**Coal Combustion Waste Impoundment  
Round 5 - Dam Assessment Report**

*Lansing Smith Plant*

*Ash Pond Embankments*

*Gulf Power Company*

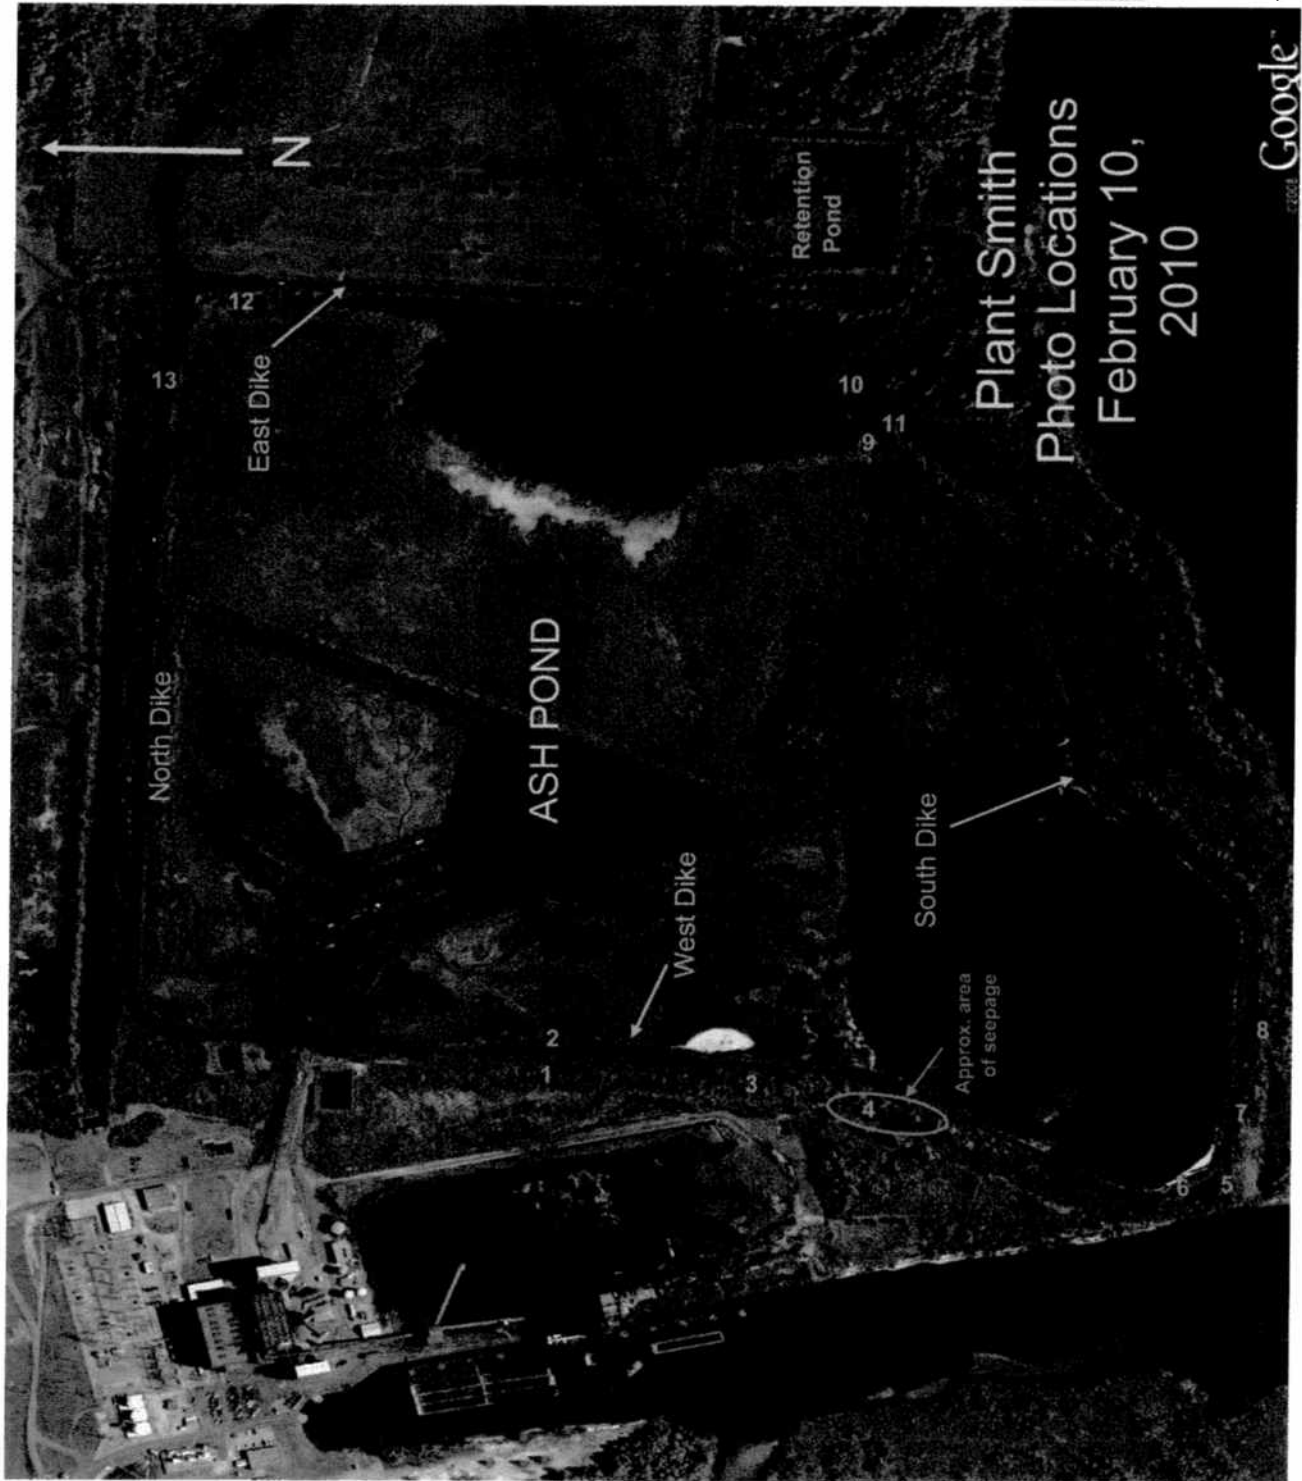
#1 - Additional grass should be planted (hydro-seeded) on all dike slopes for summer growth. (This action will complete Previous Recommendation #1, see below)

#2 - Seepage found on the slope, near the toe, should be monitored along the area of the West Dike as part of weekly plant inspections. Any sloughing or loss of material observed during the weekly inspection should be reported to SCG Hydro Services immediately.

No.	Description	Location	Photo No.
1	Plant (hydroseed) additional grass on all dike slopes for summer growth. (This will complete previous recommendation #1, see below)	All dikes.	3, 5, 8 and 10
2	Monitor seepage in this area of the West Dike as part of weekly plant inspection. Any sloughing or loss of material observed during the weekly inspection (or at anytime) should be reported to SCG Hydro Services immediately.	West Dike	3 and 4
3	Sign to be placed at granular stockpiles to mark them for "Emergency Dike Repair Use Only".	South end of the West Dike	6

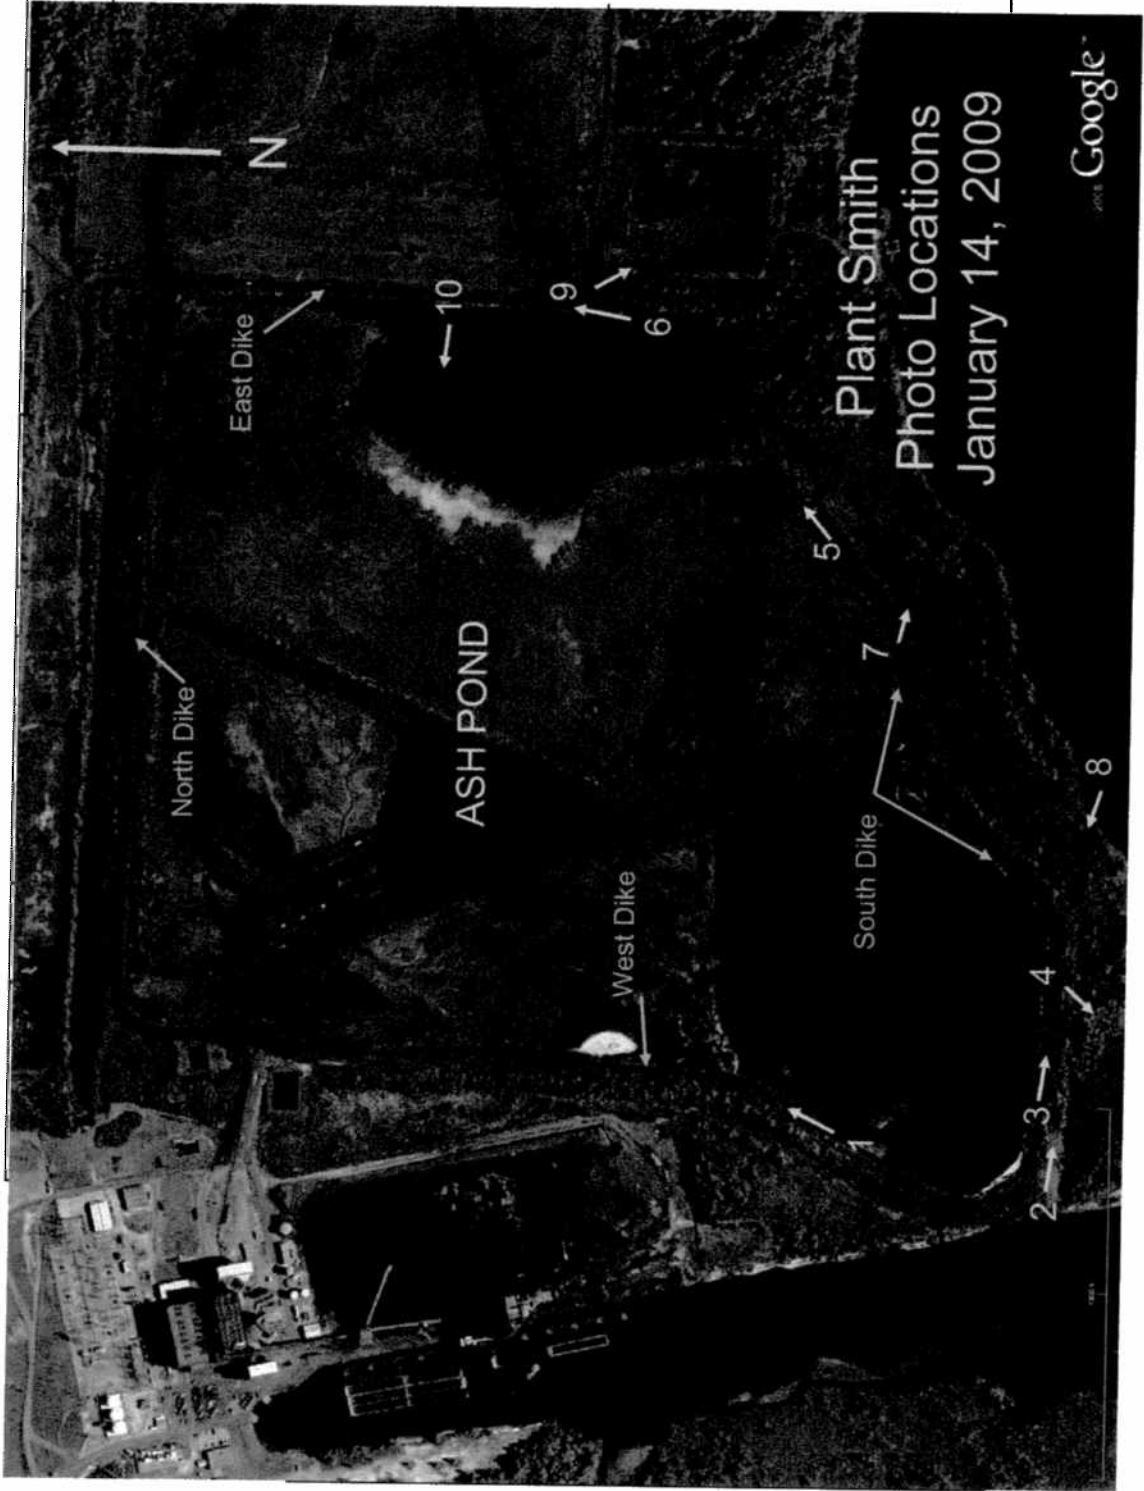
There are some questions that need to be answered before the safety of the ash pond can be determined. From a visual observation, the ash pond dike slopes appear somewhat steeper than what is generally accepted and it is not clear of what materials the dike is constructed. These issues should be investigated. It would also be prudent to perform a storm routing analysis on the pond to determine the hydraulic adequacy of the outlet and to determine the safe operating level.

There are some maintenance issues that need to be addressed. In addition to the removal of the trees and brush from the dike slopes, the crest of the dike requires some repair and grading to prevent ponding of water and to direct runoff into the pond. It would also be prudent to provide access around the toe of the dike for equipment and to stockpile granular filter materials at the toe for use in emergency repairs. It is our understanding that the implementation of these recommendations could depend on wetland permitting.

No.	Description	Location	Photo No.
1	Trees and brush on the upstream and downstream of all dike slopes should be removed and slopes grassed and maintained. The process of tree removal and root ball repair should be done in accordance with the guidelines and procedures set forth in FEMA Publication #534, "Impacts of Plants on Earthen Dams", pages 6-1 through 6-12.	Most of the dike as typified in photos.	1,2,3 and 5
2	A survey of the crest elevation on a 10 foot spacing should be performed to confirm the elevation and to aid in repair efforts.	All of the perimeter dike.	
3	Using the survey information the crest should be graded to direct drainage into the pond. Traffic ruts and potholes on the dike crest should be filled with soil and then gravelled to prevent water from standing/ponding on the crest. Downstream slope erosion should also be repaired.	All of the perimeter dike.	3,4 and 5
4	Construction techniques and materials used for original construction of the dike and for any subsequent repairs, should be evaluated for suitability and stability. This will require some drilling and sampling of the dike material plus surveying to determine the dike geometry.	All of the perimeter dike.
